PREVOST Warranty Bulletin

NO: 94-23 **SECTION**: 13

SUBJECT: HUB BEARING ADJUSTMENT FOR GKN MADE AXLE

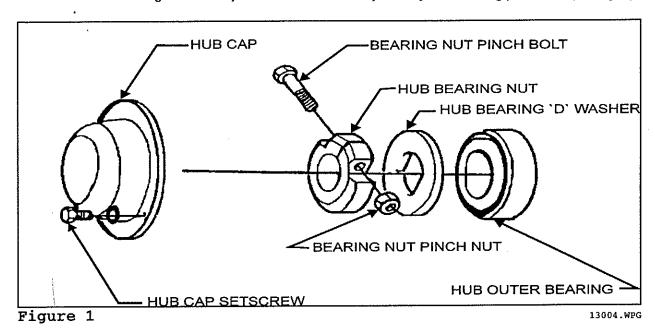
Some H3-41 and H3-45 vehicles equipped with front and tag axles made by GKN have a wrong cone bearing adjustment. To detect it, grap the tire by the two opposite points on its perimeter and rock it to see if there is a slack.

The hub bearings affected by a slack should be readjusted by the following procedure (see fig. 1):

- 1. Park vehicle over a safe lifting equipment. Apply parking brake, stop engine and set battery main switches to the "OFF" position. Raise the vehicle by its jacking points on the body. Consult H3-40 Maintenance Manual, Section 18 under heading "Vehicle Jacking Points".
- 2. Remove the hub cap by unscrewing hub cap setscrew.
- 3. Unscrew the bearing nut pinch nut.
- 4. Screw the bearing nut at the end of the spindle until the elimination of the slack without creating stress on the bearings.
- 5. Tighten the hub bearing pinch bolt nut to 24-26 lbf-ft (33-35 N-m) and the hub cap setscrew to 85-103 lbf-ft (115-140 N-m).
